Memorandum

To: Dan Berman, Trinidad City Manager Ref. No.: 01063-07-001

Subject: Storm Damage – Scenic Drive/Parker Creek

Figure 1 – Approximate locations of site observations

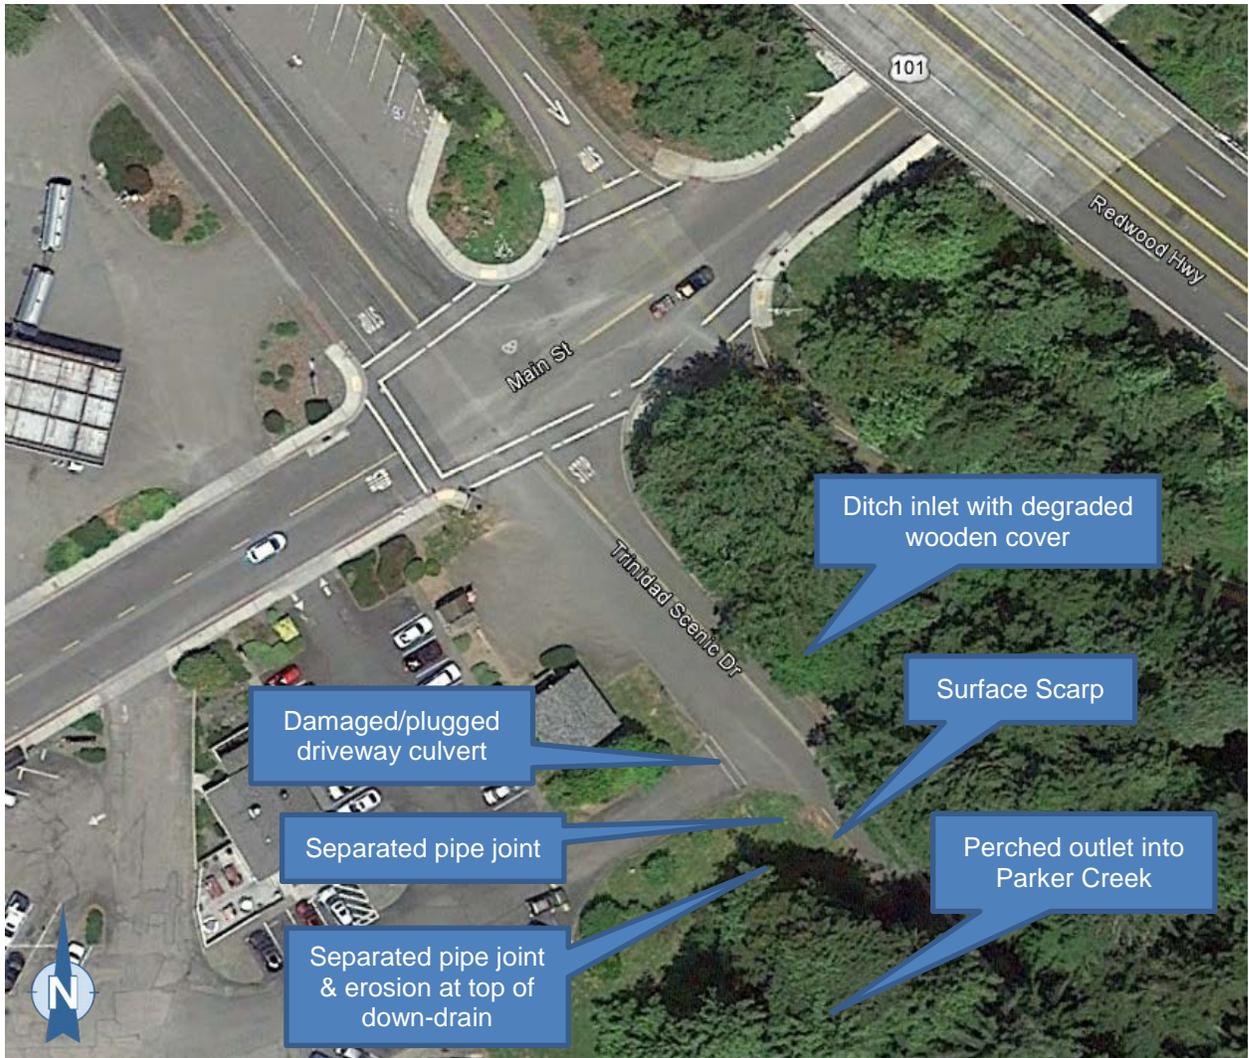
Damaged culvert at driveway to Saunders Shopping Center – The ends of the driveway culvert appear to have been damaged/crushed by vehicles. The downstream end appeared to be plugged with sediment and debris. The culvert did not appear to be in a suitable condition to adequately convey stormwater.

Degraded wooden cover to ditch inlet on east side of Scenic Drive – The wooden cover to the concrete ditch inlet appeared to be severely degraded which has allowed vegetation and debris to partially cover the inlet and limit the inlet capacity.

Separated storm drain pipe joint in Scenic Drive shoulder area with moderate surface erosion – The joint of two CMP culverts has failed/separated allowing surface runoff to enter the pipe. Active surface erosion visible in the area of the failed joint and it is likely to continue and get worse if no action is taken. See Photo 1.

Separated pipe joint at top of down-drain to Parker Creek with significant erosion – The joint at CMP culvert and CMP down-drain has failed/separated allowing surface runoff to enter the pipe. Active surface erosion is visible in the area of the failed joint and it is likely to continue and get worse if no action is taken. See Photo 2.

Ground surface scarp on west side of Scenic Drive – An approximately 30' long surface scarp was located just off the west shoulder edge of Scenic Drive. The scarp is likely evidence of active embankment slumping (the road embankment slumping towards Parker Creek). The slumping is likely to continue and get worse if no action is taken. See Photo 3.

Perched down-drain outlet into Parker Creek – The outlet of the down-drain is perched 2-3' above the channel. The outlet pipe appeared to be intact with no visible holes in pipe and no visible signs of piping (drainage flowing on the outside of the pipe). The channel at the outlet is composed of bare ground, rocks, wood, logs, concrete rubble and other material. Only limit erosion was observed at outfall. See Photo 4.

- Install new concrete inlet (type G1 or similar) at the upstream joint separation (in road shoulder). Connect separated sections of pipe with chain or cable to prevent/limit further separation.

- Repair downstream joint separation (CMP or rubber collar). Connect separated sections of pipe with chain or cable to prevent/limit further separation.

- Construct AC dike (extruded or hand-formed) to divert all surface runoff (to the extent practical) into new inlet and pave area between new AC dike and roadway (4" AB and 2" AC).

- Repair or replace driveway culvert at Saunders Shopping Center (this work may be the responsibility of the property owner and not the City).
- If Sanders driveway cross-culvert is too deep to surface drain to new inlet, then it should be connected with a new storm drain pipe (12" min.).

- Replace wooden lid on ditch inlet (east side of Scenic Drive) and regrade ditch as required.
